SERVICE INSTRUCTION CK-SI004 Rev NC Page 1 of 5

SUBJECT: *IGNITION COIL BRACKET RETROFIT*

MODELS AFFECTED: *CCK-1865 Kits shipped prior to June, 2021
CCX-1865 S/N 0001-0030*

FIGURE 1 – SPARK PLUG AND IGNITION WIRE LABELING

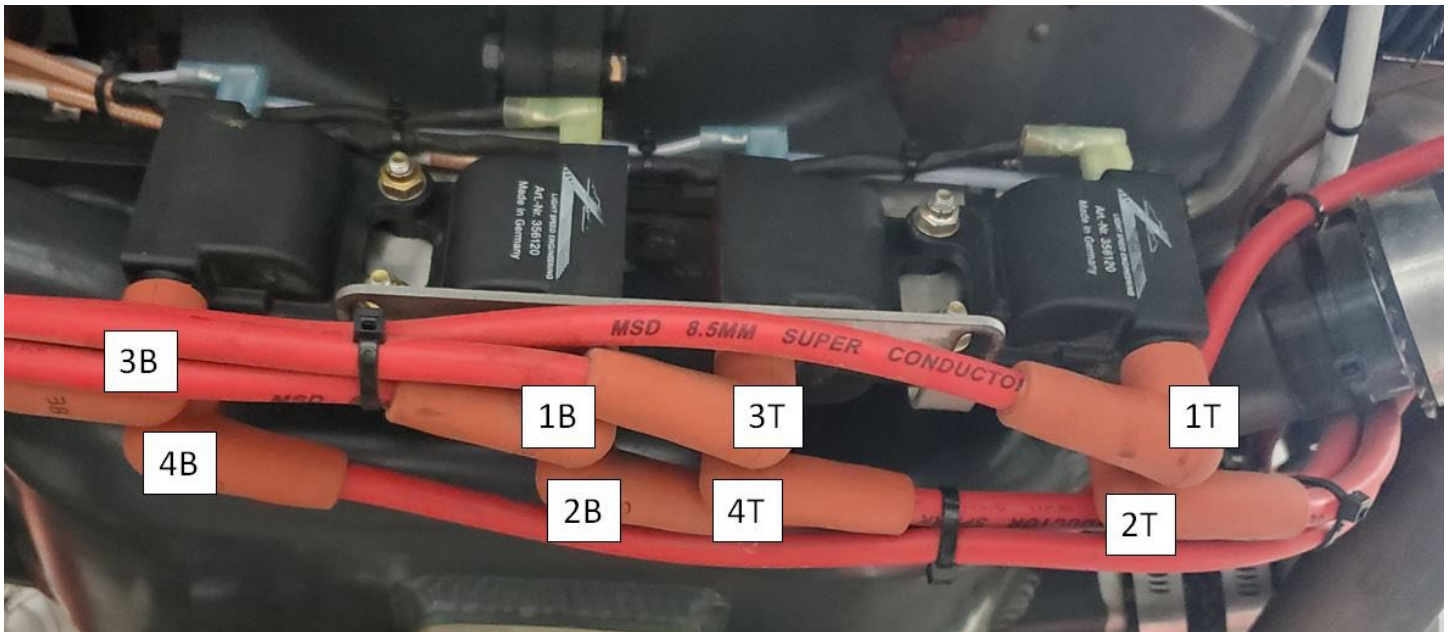
1. Read all instructions before beginning any work.
2. Remove the engine cowling per the Aircraft Maintenance Manual (CK10000AMM).
3. Label each spark plug wire and corresponding ignition wire (the spade connection opposite each spark-plug wire stud) as shown in Figure 1. Then remove the spark plug wires and ignition wires from the ignition coils.

FIGURE 2 – COIL INSTALLATION

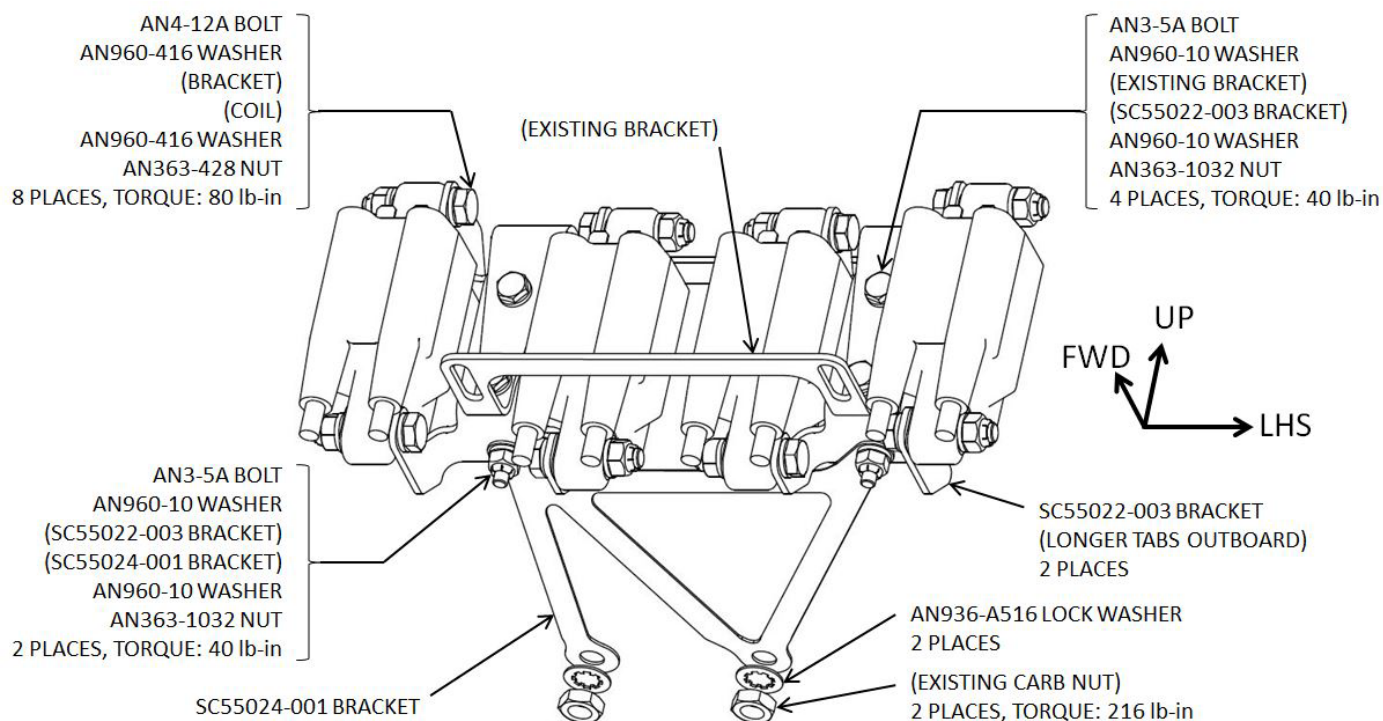
- Install SC55022-003 brackets on each of the two vertical portions of the existing bracket as shown in Figure 2. Note that the longer coil mounting tabs on SC55022-003 brackets should be positioned outboard of the existing bracket. (This will position the outer two coils slightly forward of the center two coils).

- Install the new style ignition coils on the SC55024-001 brackets as shown in Figure 2. Note that hardware is easiest to access if the center two coils are mounted on their respective brackets before mounting the brackets in Step 7. The outer two coils should be installed after the brackets are mounted.

- Install the SC55024-001 stay bracket between the SC55022-003 brackets and the two forward carburetor mounting studs as shown in Figure 2. Use the two original carburetor nuts removed in step 5, each with a new AN936-A516 washer. Apply torque stripe after torquing.

FIGURE 3 – IGNITION COIL CONNECTIONS

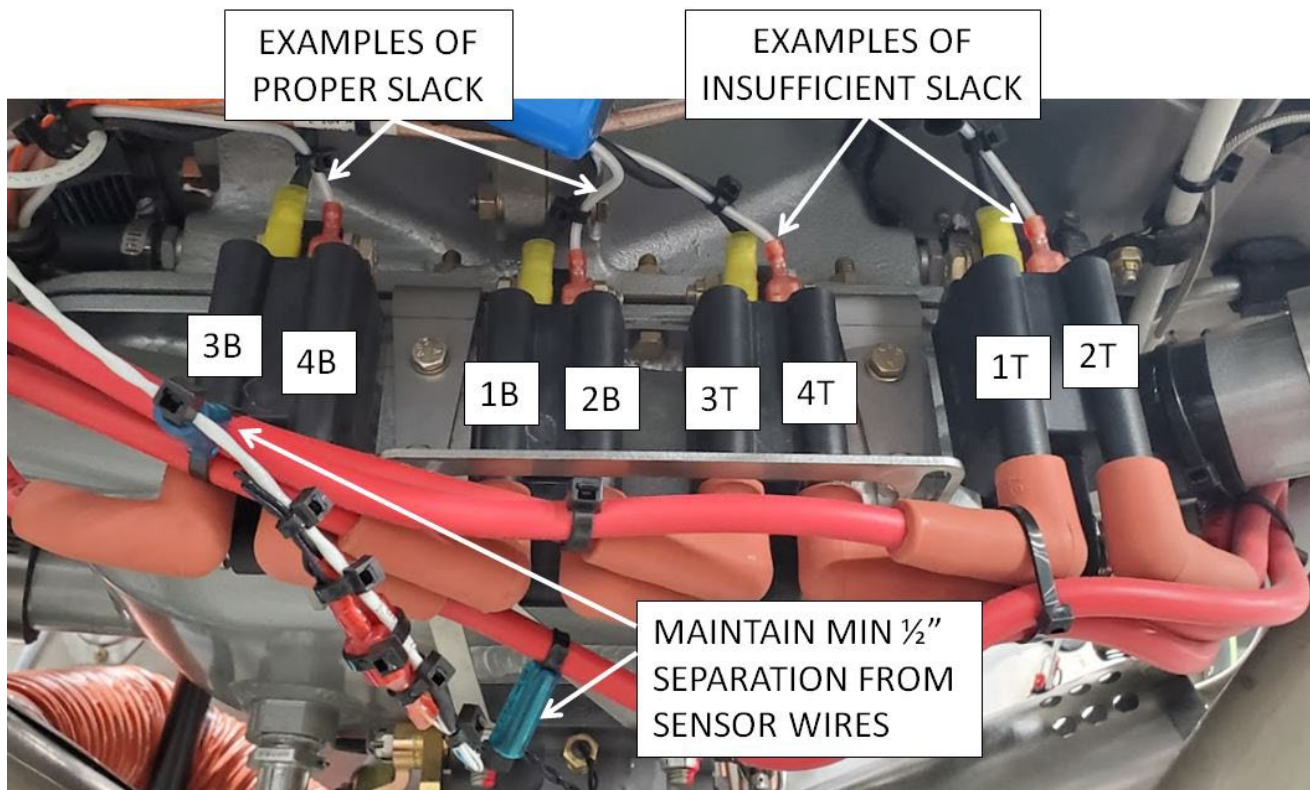
- Install the spark plug wires and corresponding ignition wires as shown in Figure 3. Note that the two ignition wires and the two spark plug wires connected to each coil are not polarity-sensitive. Ensure plug wires click and seat fully onto studs. Ensure spade connectors fit tightly onto the coil, and ignition wires have proper slack, referring to SK-SB010 for more detail. Should it be necessary to replace the ignition wires to achieve proper slack, wire and heat shrink part numbers are given as reference in the parts list. Spark plug wire part number information is given in Appendix A.
